19. PROBABILISTIC RISK ASSESSMENT AND SEVERE ACCIDENT EVALUATION

19.1 Probabilistic Risk Assessment

Figure 19.2-1 ESBWR design features for severe accident conditions

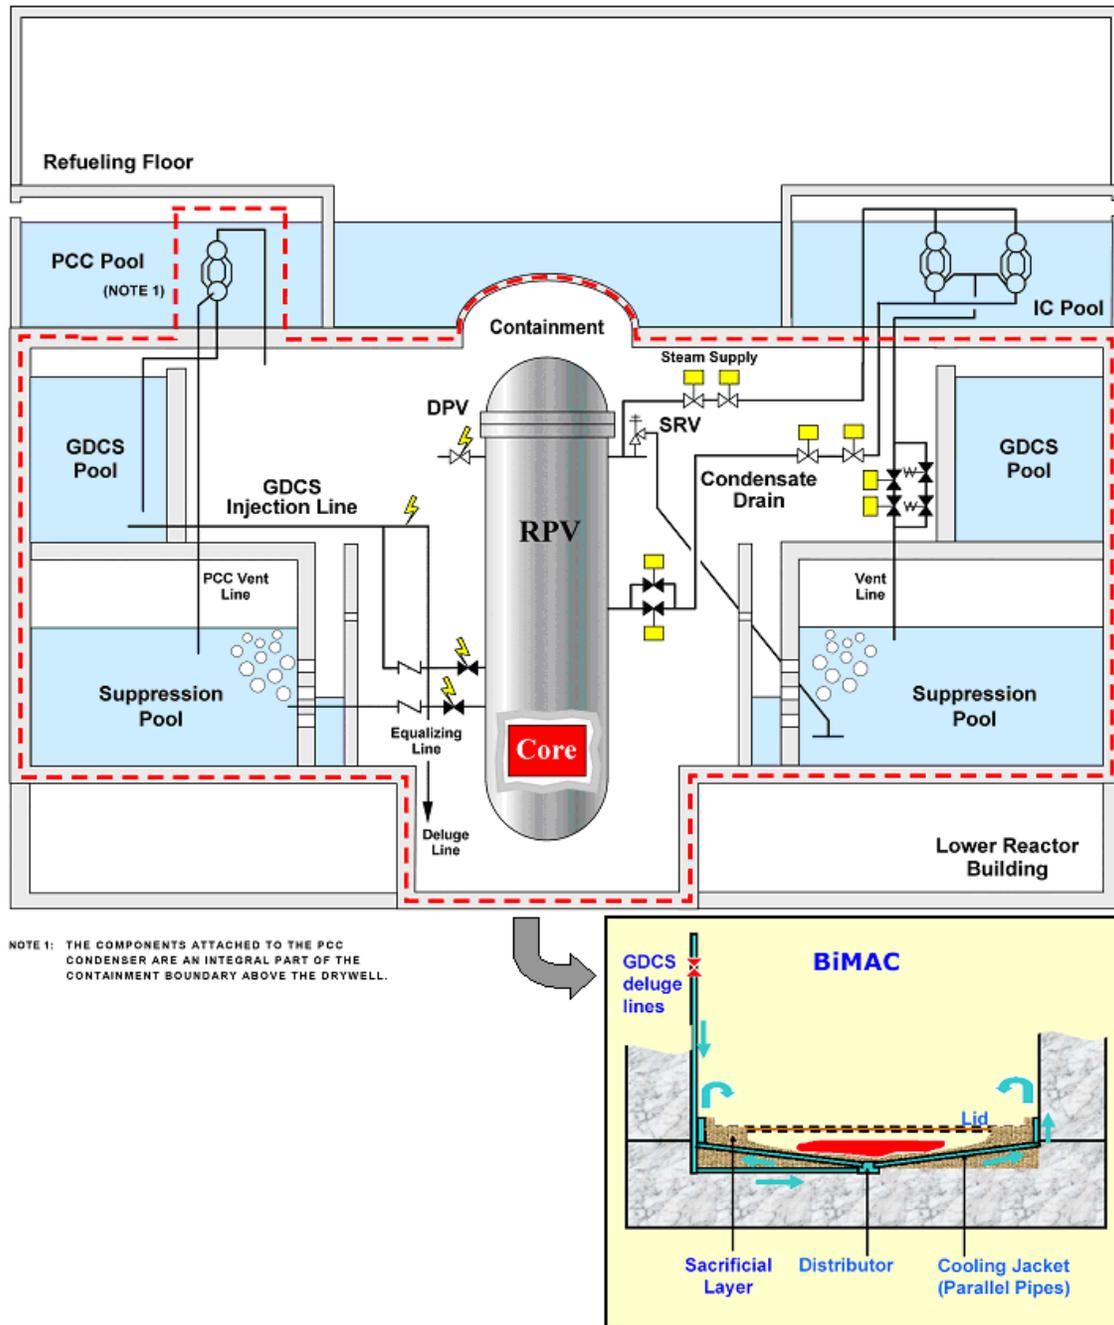
Figure 19.2-1 illustrates the ESBWR containment design features that would mitigate severe accidents, and Section 19.1.3.1.1 discusses the major features.
